## Response to Submissions

SSD 8544 Glebe Island Concrete Batching  
Plant and Aggregate Storage Facility

Submitted to Department of Planning and  
Environment on behalf of Hanson Construction  
Materials Pty Ltd

**Figure 1 Amended Site Plan**

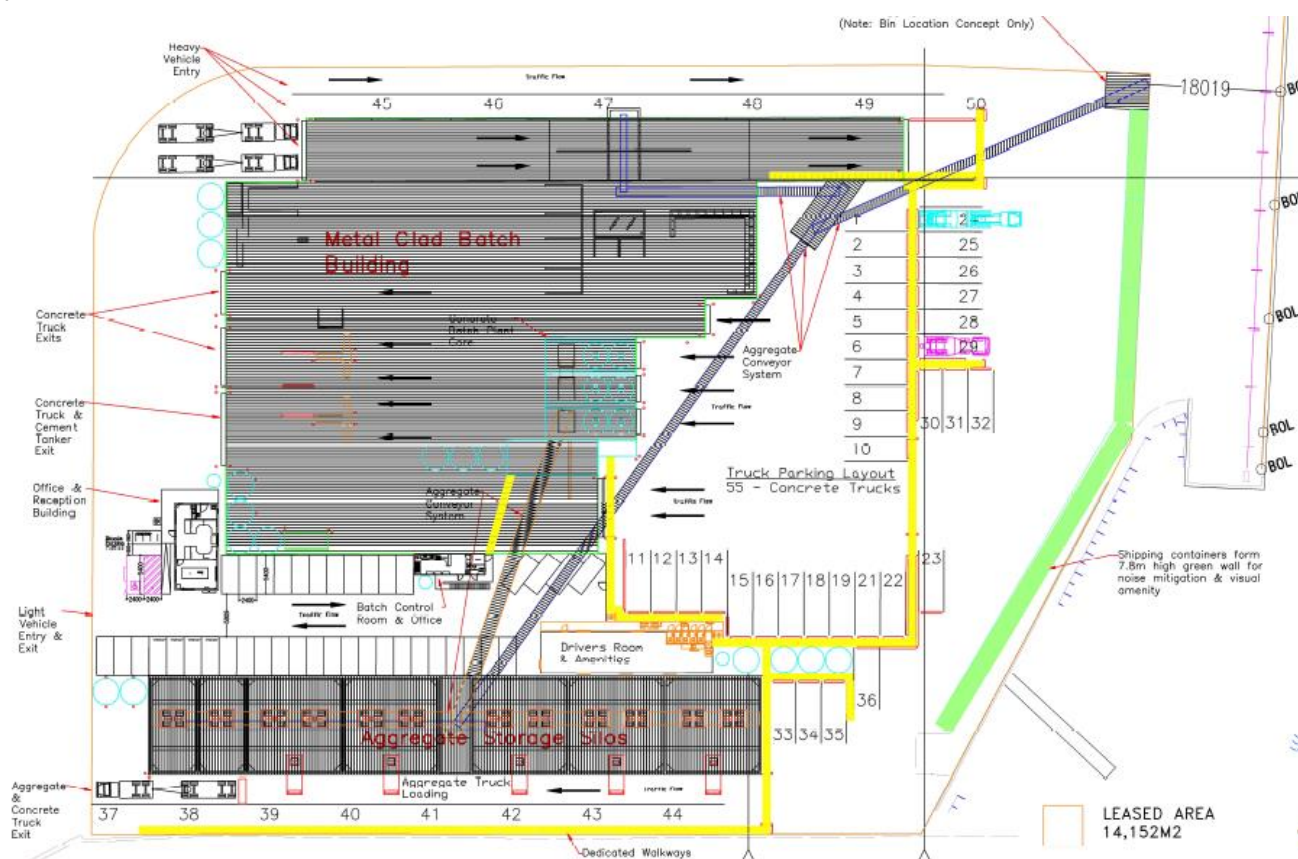
A revised site plan has been prepared by Hanson in consultation with Port Authority and is provided at **Appendix K**. The revised plan is proposed to supersede the original site plan submitted with the EIS. An excerpt of the amended site plan is provided at **Figure 1**. Elevation Plans are also provided at **Appendix K**. Key changes are summarised below:
